Housing Incentive Program Expansion and 788 San Antonio Road Mixed-Use Project

Final Environmental Impact Report/
Responses to Comments on the Draft EIR

SCH#2019090070

Figure 1. Even for small, residential properties “controlled groundwater pumping” affects a very large area.

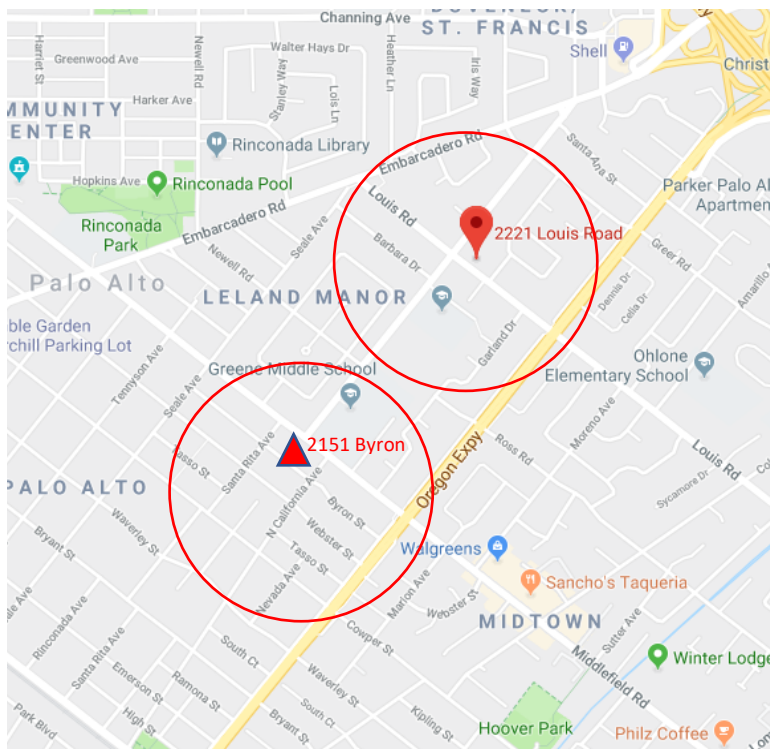
Appendix A Dewatering Impacts a Large Area

The following is actual data from two residential dewatering projects in Palo Alto. In both cases, the basement excavation depth was approximately 5 feet below the groundwater level at the start of the project, “controlled groundwater pumping” was used, and pumping rates were approximately 150 – 200 gallons per minute. The monitoring well was located approximately 1,100 from one site and 1,900 feet from the other site. Dewatering lowered the water table approximately 2 feet at the monitoring well, clearly showing the large area impacted. Note any contaminant plumes in this area would be mobilized. The 788 San Antonio Project would have much larger impacts as the groundwater for a 2-story underground parking would be lowered by approximately 20 feet and the area of the project is larger.

Dewatering significantly impacts a very large area

The commenters state an opinion that no quantitative analysis of the amount of groundwater pumped and discarded is included to support the conclusions in the Initial Study and cites data that show that groundwater pumping for two residential basements lowered the groundwater levels in the surrounding area. The commenters also state an opinion that the conclusions in the Initial Study related to groundwater depletion do not account for the cumulative impacts, including those allowed by the HIP Expansion and listed in Table 3-1 of the Draft EIR.

In accordance with CEQA Guidelines §15124, the project description "should not supply extensive detail beyond that needed for evaluation and review of the environmental impact." Information on the specific location of the dewatering features and the amount of pumping that would be required are not necessary to evaluate and review the potential environmental impacts of the project. Consistent with CEQA Guidelines §15123, the Initial Study contains a brief summary of the proposed actions and its consequences, in this case, as they relate to impacts on hydrology and water quality. In addition, the analysis in the Initial Study provides a sufficient degree of detail through reference to the City's dewatering regulations. Specifically, as outlined under Response 5.2, it is anticipated

that groundwater would be encountered during project construction and that the project applicant would therefore be required to prepare a Construction Dewatering Plan that is consistent with detailed requirements and performance standards contained in the *City's Dewatering System Policy and Plan Preparation Guidelines*. Prior to excavation activities for the project, the City of Palo Alto Public Works Engineering Department would review the project's Construction Dewatering Plan to ensure that the *Guidelines* are followed. Therefore, adherence to the Palo Alto Municipal Code with respect to dewatering requirements would ensure the impacts related to the water table at the program area and project site would remain less than significant. Moreover, other projects allowed by the HIP expansion would also be reviewed by the Public Works Engineering Department, and, in the cases where groundwater is likely to be encountered, would also be subject to their own Construction Dewatering Plans. Therefore, cumulative impacts related to the water table would also be less than significant.

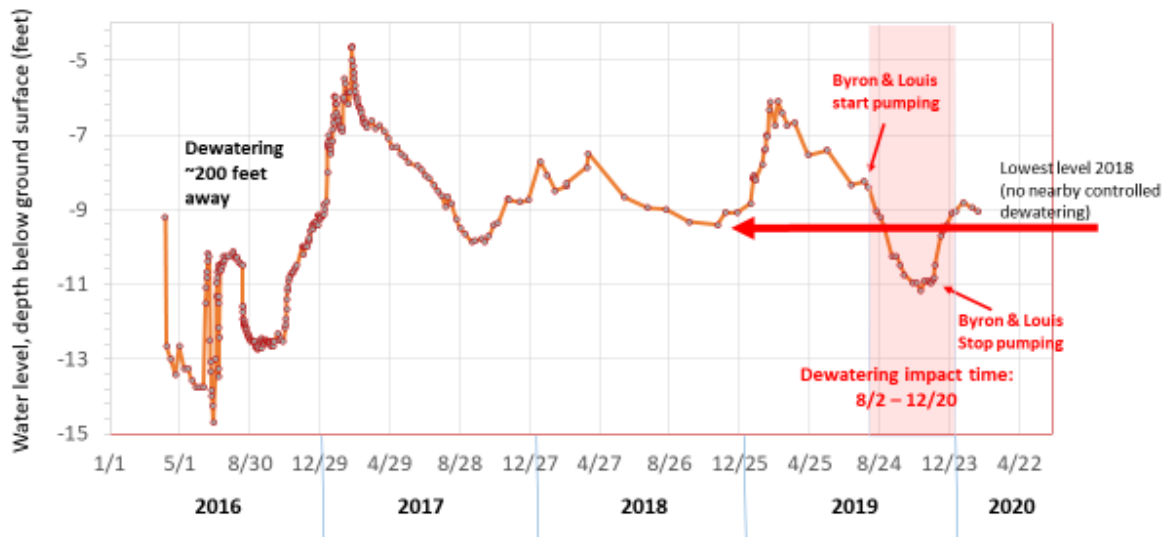
Groundwater rises from November through April are due to rain storms. Water level drops between rain events due to groundwater flows – a significant part of Palo Alto’s stormwater management natural infrastructure.
